**ADDENDUM NO. 05**

August 11, 2010

**Project:** Package A – 2010: Misc. Renovations and Additions to Cook Middle School and E.L.C. No. 2  
 Cypress-Fairbanks Independent School District

Bay Project No.:0930 (10-02-2196R-FP)

**PARTIAL DEMO. SITE PLAN - FINE ARTS WING - 6/C1.02-co**

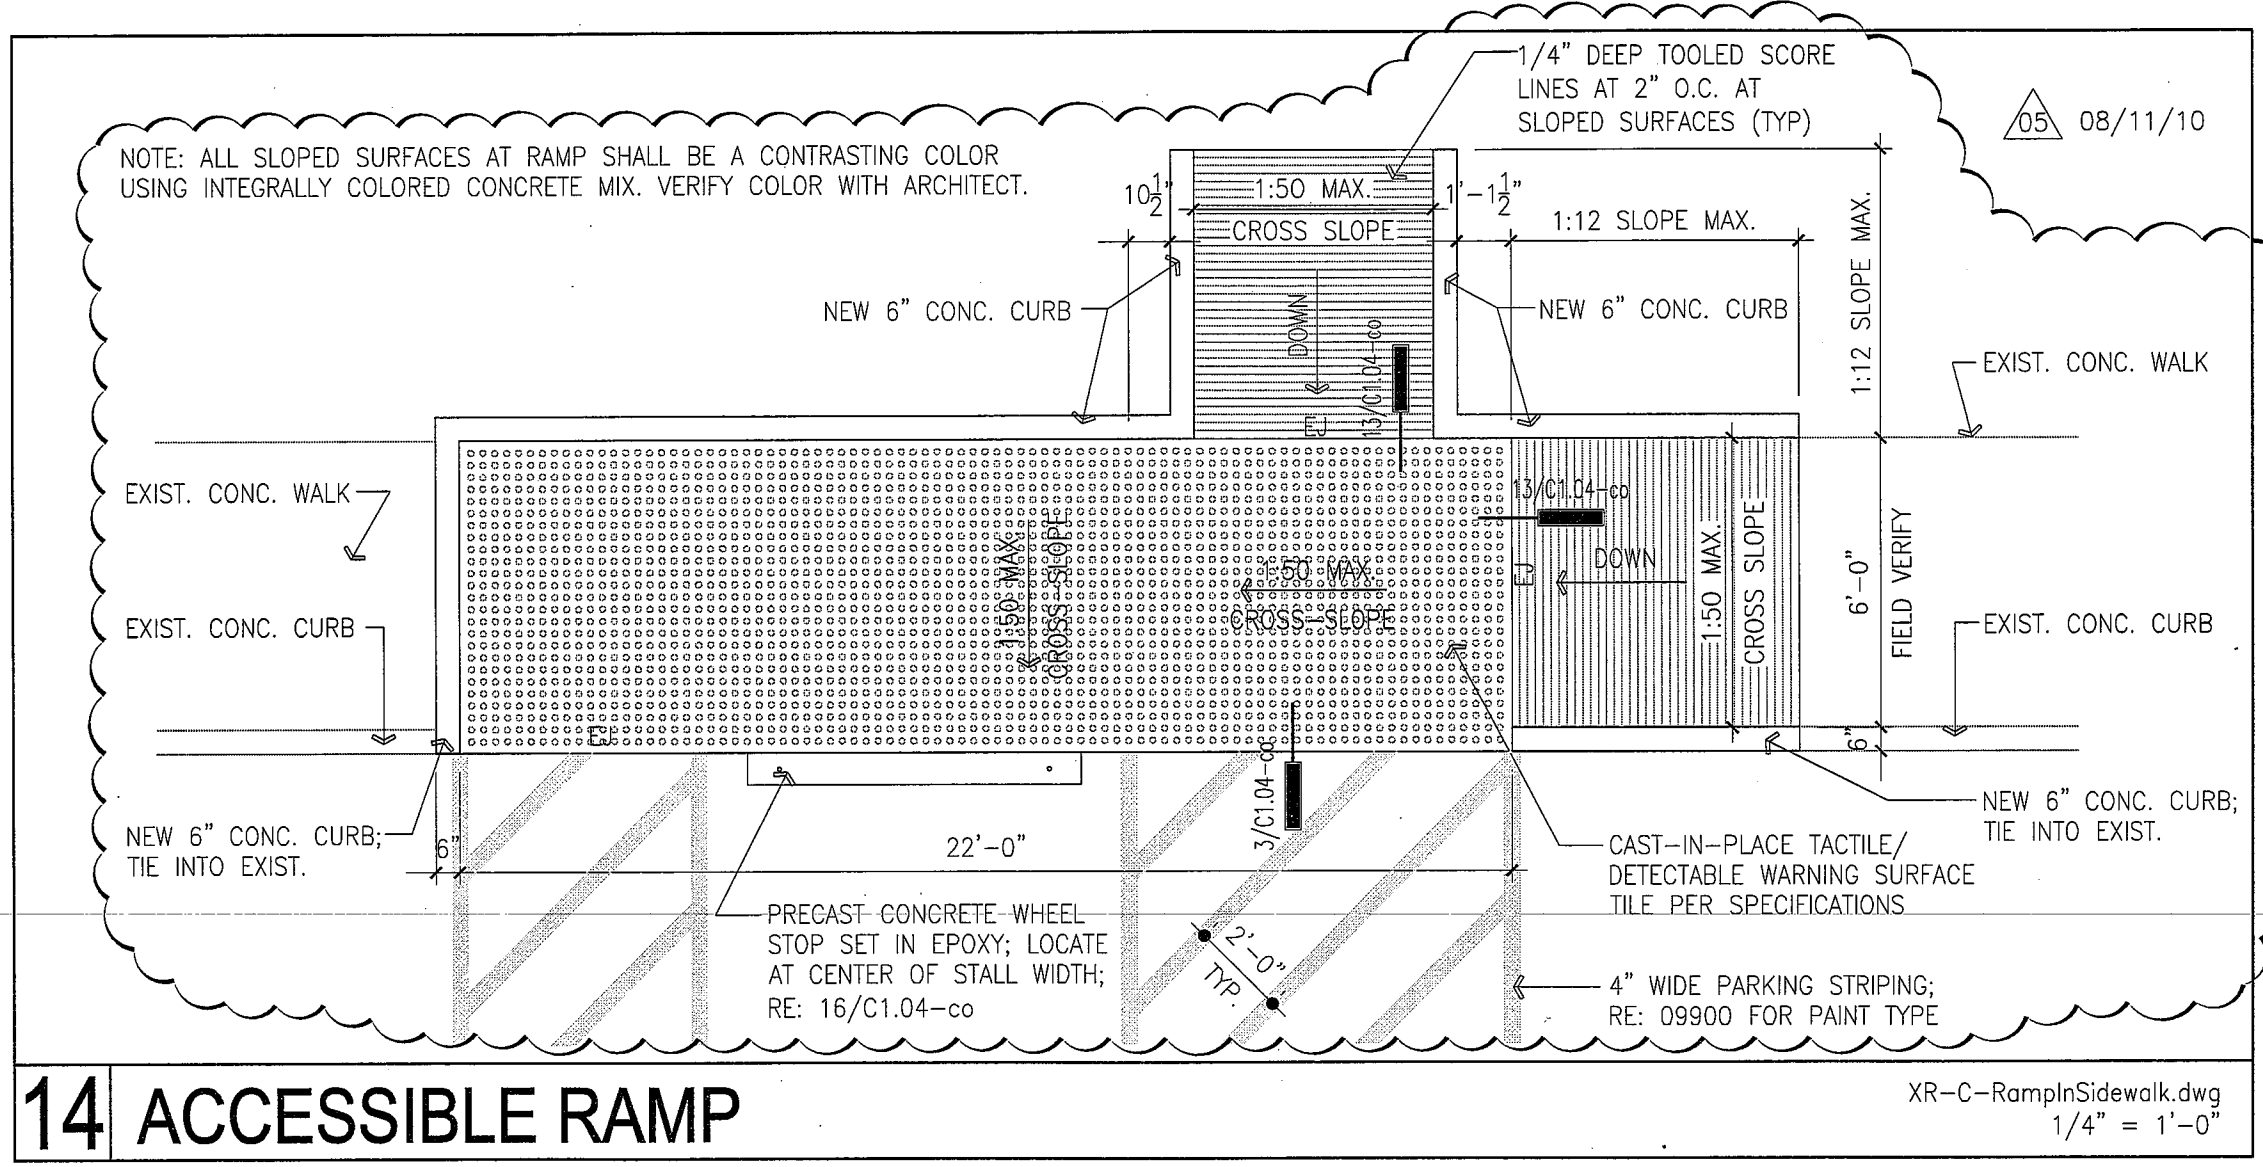
08. Sheet C1.02-co  
a. Drawing /C1.026-co PARTIAL DEMOLITION SITE PLAN – FINE ARTS WING, **revise** per attached sketch SK-ADD05-01.
09. Sheet C1.04-co

REVISED DETAIL - 14/C1.04-co ACCESSIBLE RAMP

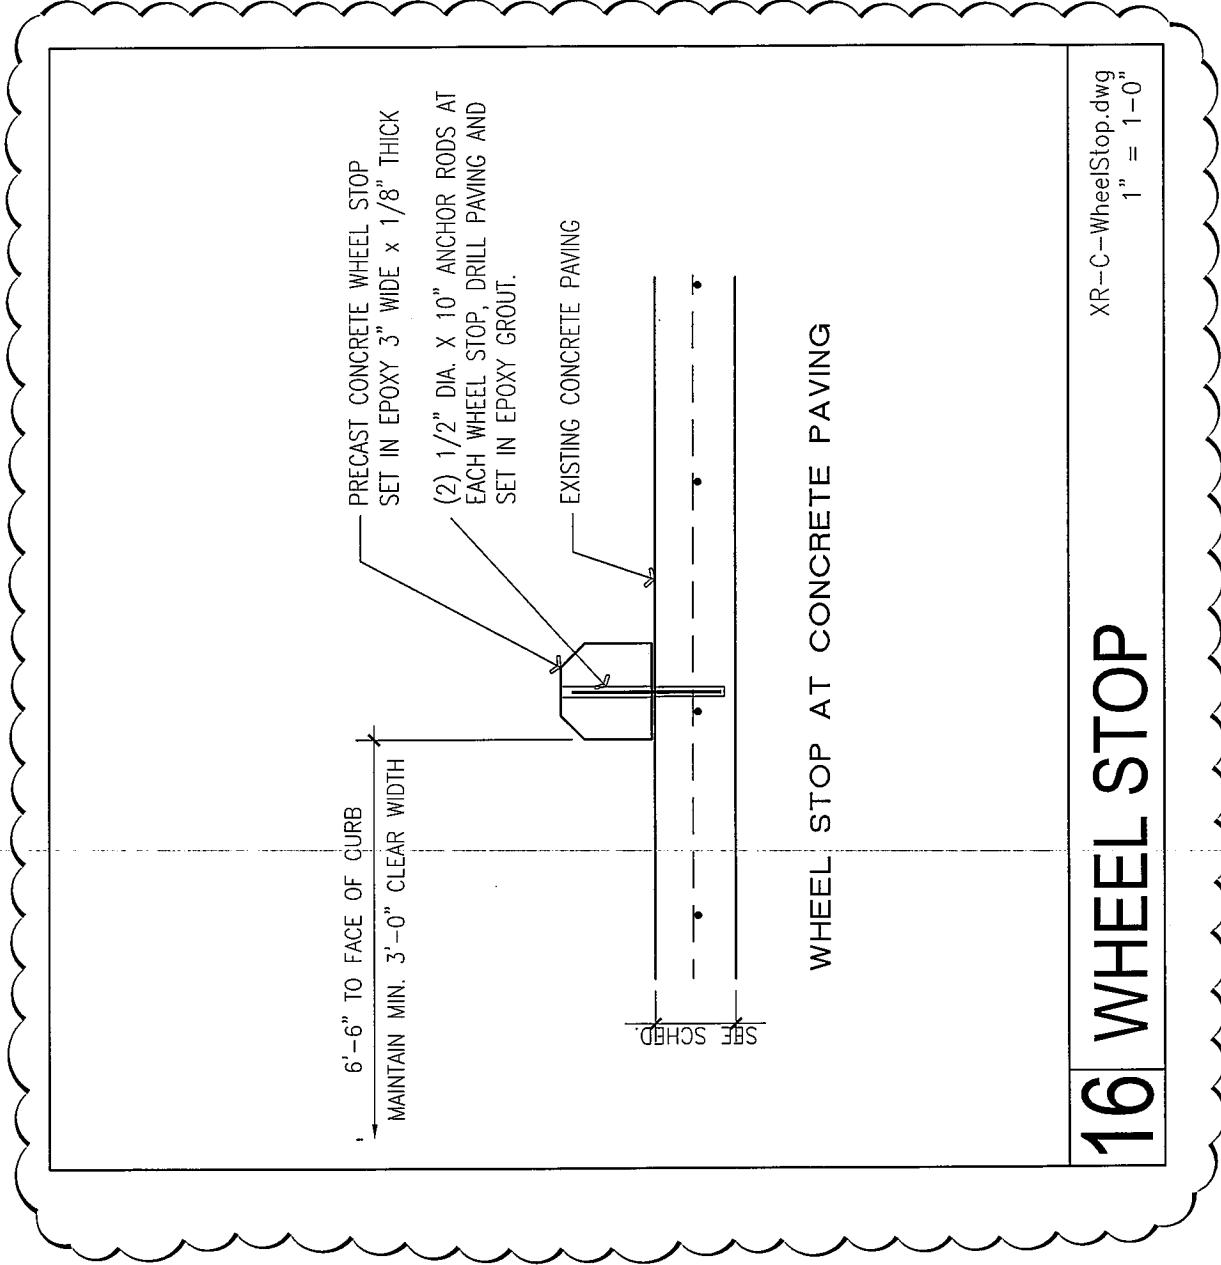
a. Drawing 14/C1.04-co ACCESSIBLE RAMP, **revise** per attached sketch SK-ADD05-02.  
b. Drawing 13/C1.04-co SECTION AT RAMP, **revise** all dimensions for the concrete thickness to read “RE: WALK SCHEDULE” in lieu of 1’-4”. Delete the following note: “SIDE SLOPE AREA BEYOND; 1:10 SLOPE MAX. AND GROOVES AT 2” O.C.” and **replace** with “CONCRETE CURB BEYOND”.

## DETAIL - 16/C1.04-co WHEEL STOP

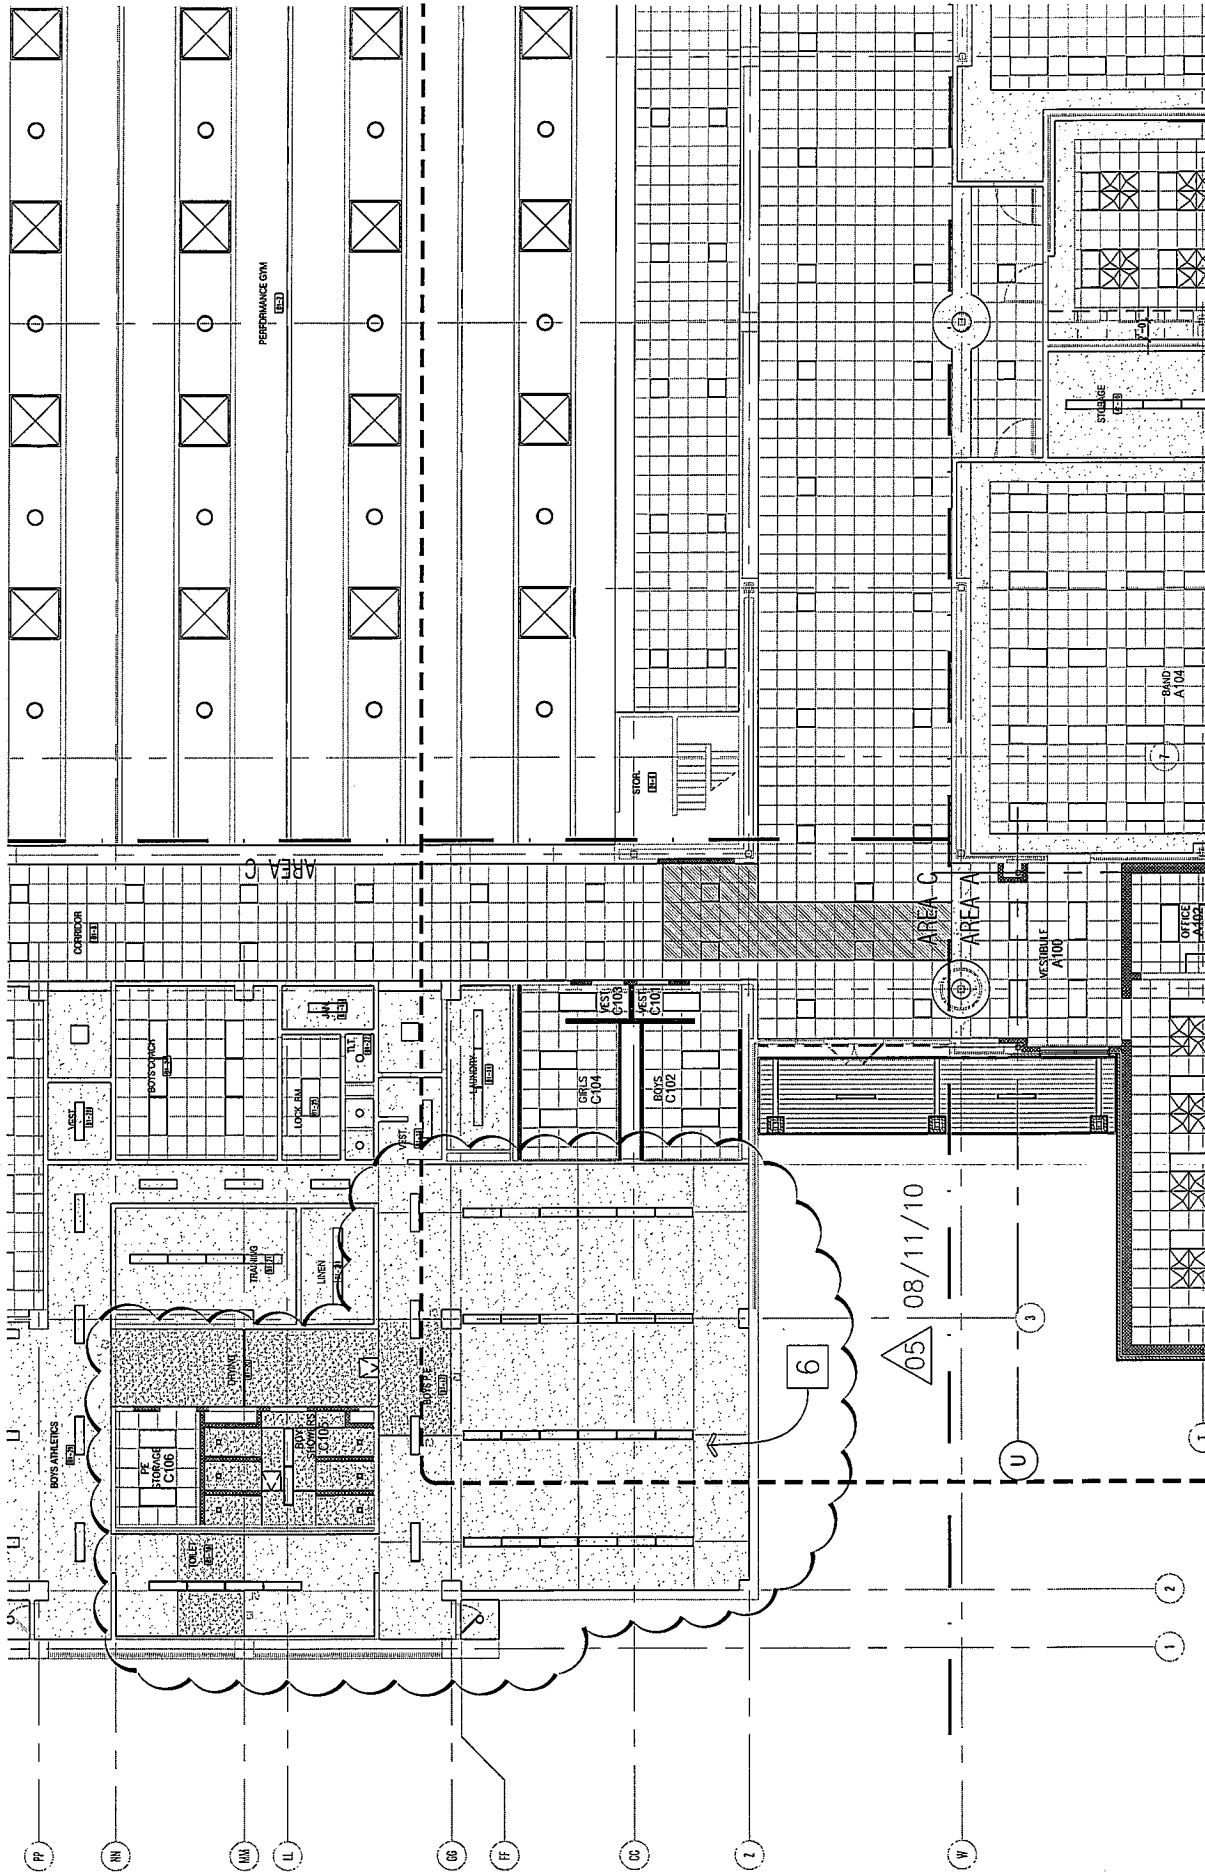
c. **Add** Drawing 16/C1.04-co WHEEL STOP, per attached sketch SK-ADD05-03
10. Sheet A1.03-co  
a. Drawing 4/A1.03-co FIRST FLOOR COMPOSITE RCP, detail bubble for Fine Arts Wing, **revise** detail reference to read “6/A2.03-co for Demo Plan” in lieu of “6/A2.04-co for Demo Plan”. Detail bubble for Boys Showers, **revise** detail reference to read “22/A2.03-co for Demo Plan” in lieu of “22/A2.04-co for Demo Plan”. Detail bubble for Girls Showers, **revise** detail reference to read “20/A2.03-co for Demo Plan” in lieu of “20/A2.04-co for Demo Plan”. Detail bubble for Girls Showers, **revise** detail reference to read “24/A3.04-co for Renov. Plan” in lieu of “20/A3.04-co for Renov. Plan”. Detail bubble for Kitchen Plan, **revise** detail reference to read “2/A2.03-co for Demo Plan” in lieu of “2/A2.04-co for Demo Plan”.

SK-ADD05-07  
 0930  
 1/8" = 1'-0"  
 08/10/2010  
 0930-SK-ADD05-07.dwg

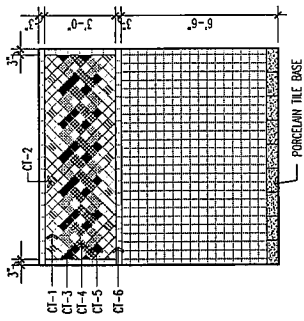
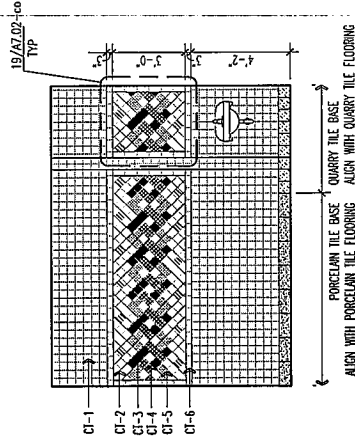
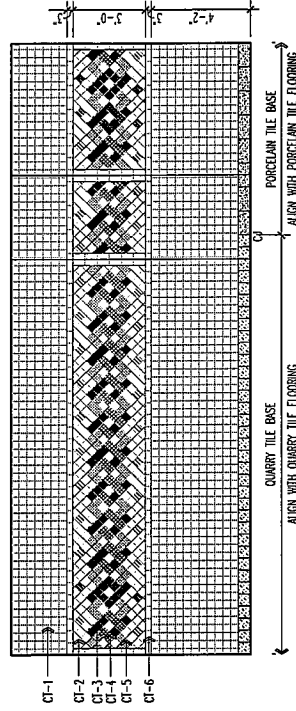
12. Sheet A7.02-co
  - a. Revise details 6, 12, 21 and 22 as per attached SK-ADD05-07.
  - b. Revise detail 19 as per attached SK-ADD05-08.
  - c. Revise details 4 and 16 as per attached SK-ADD05-09.

REVISED DETAIL - 22/A2.03-co

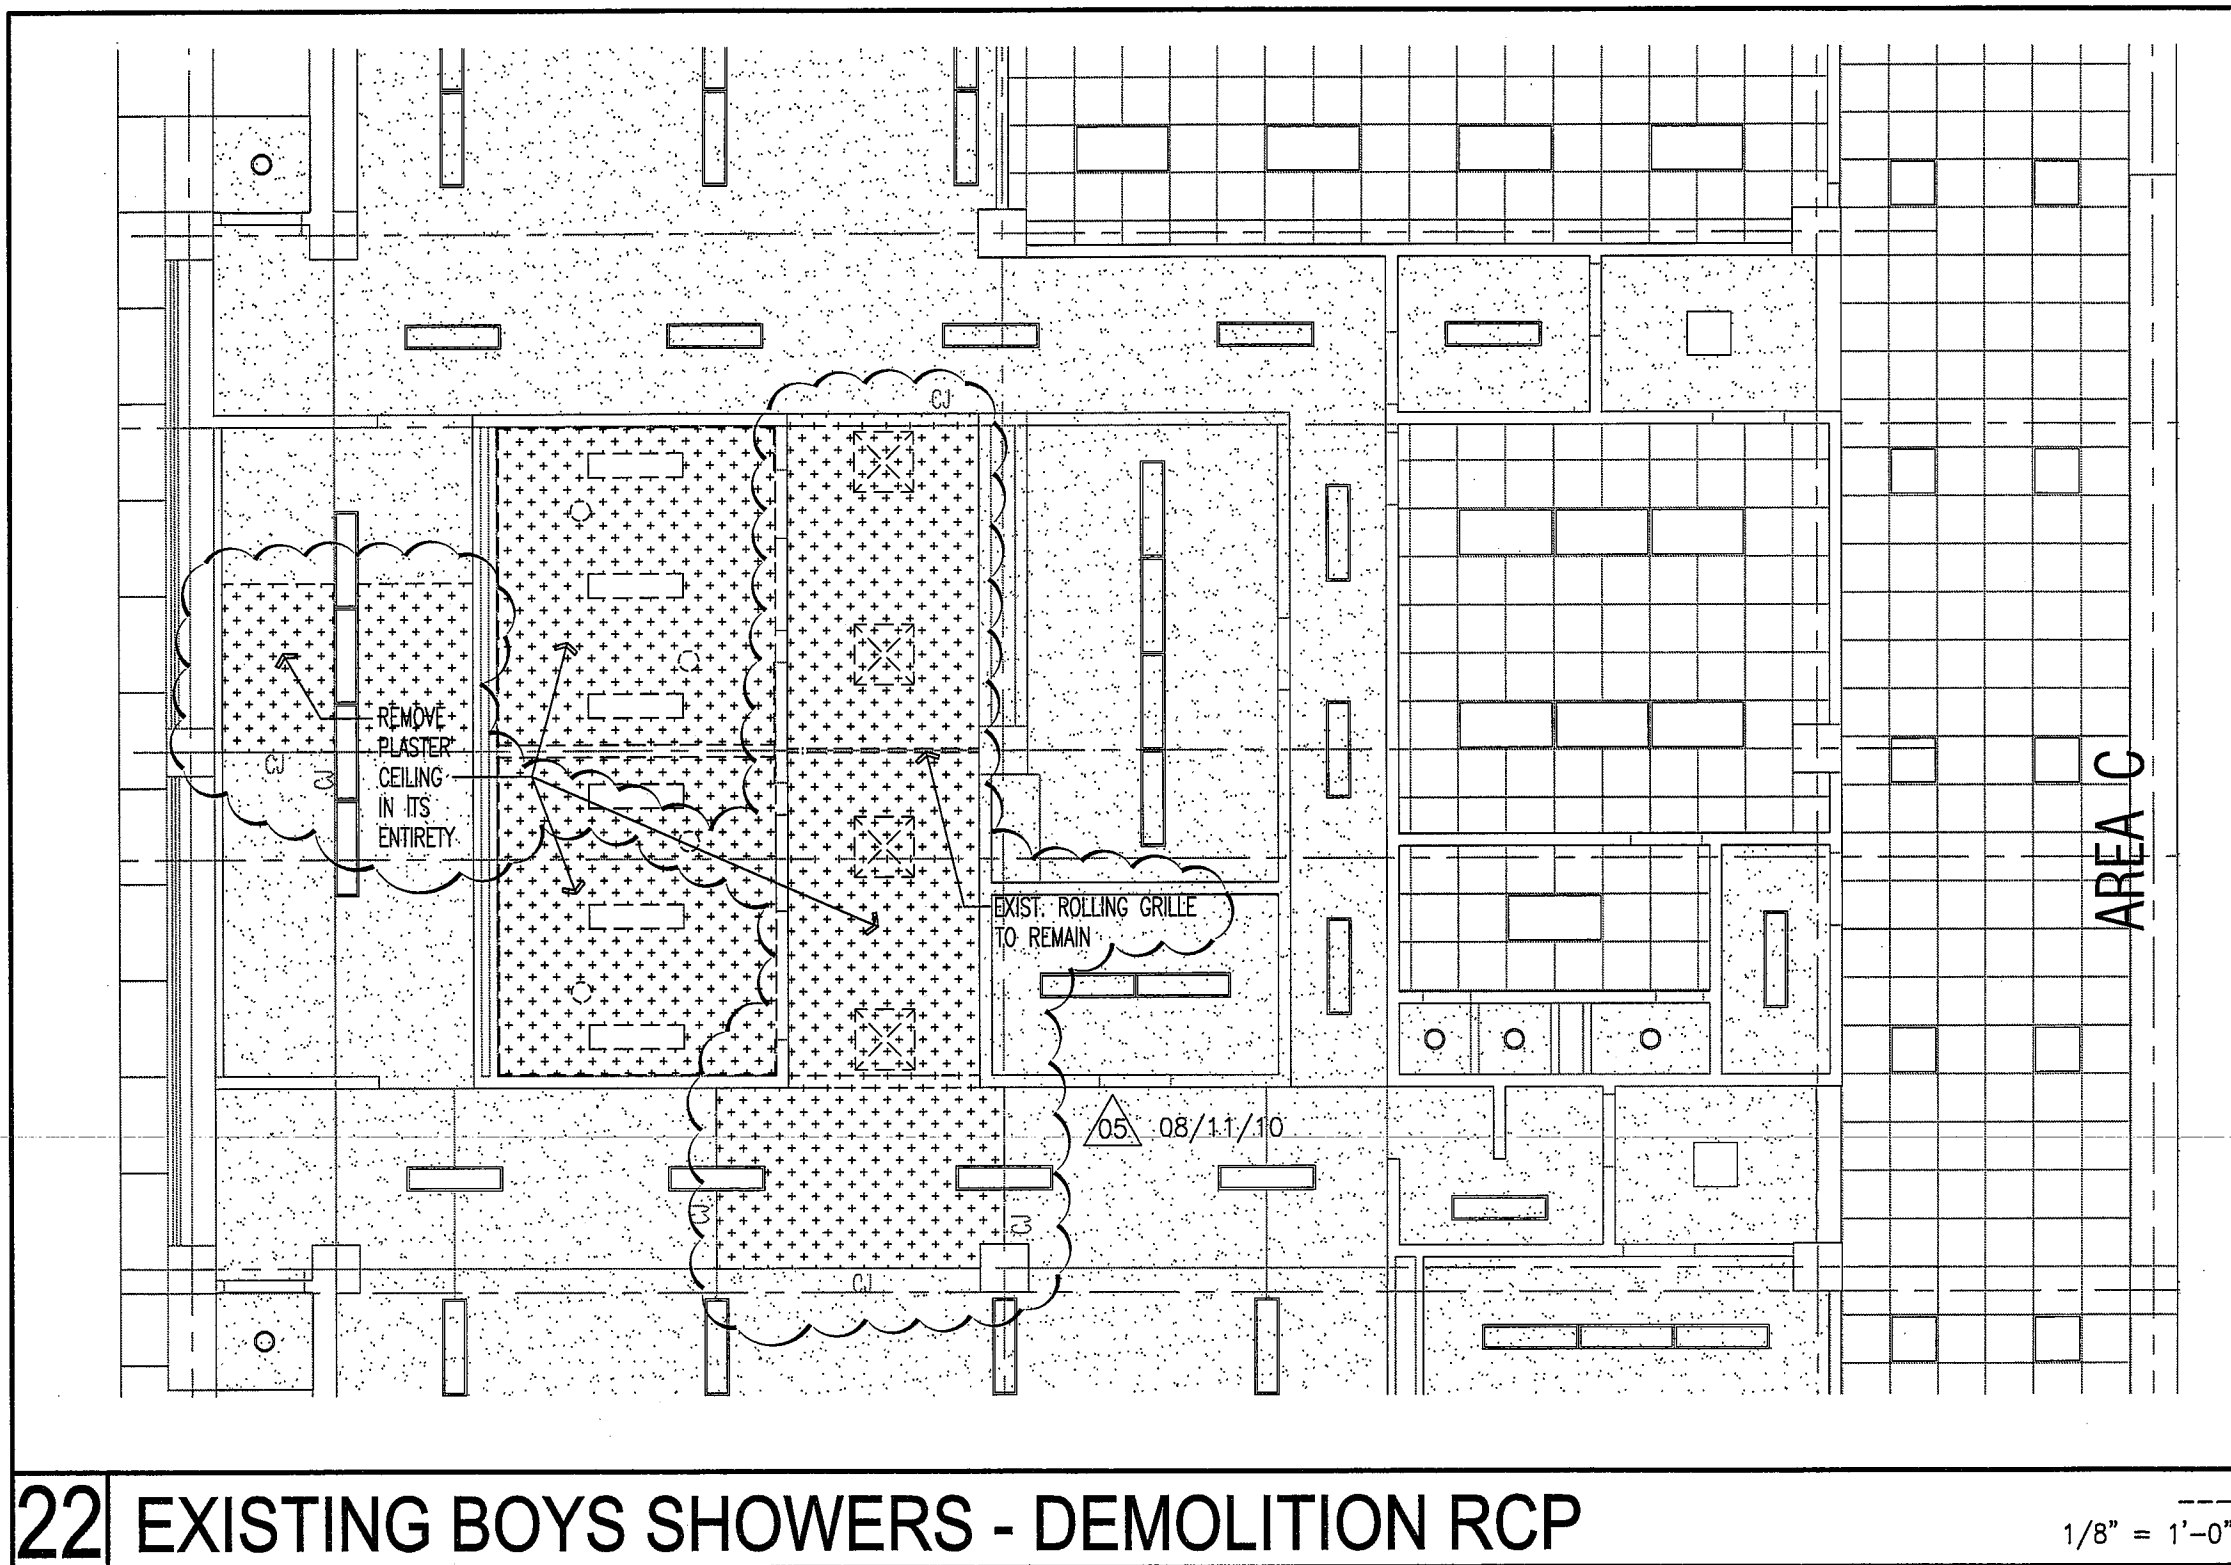
11. Sheet A2.03-co  
a. **Revise** drawings 20 & 22/ A2.03-co as shown per attached sketches SK-ADD05-06 and SK-ADD05-10.
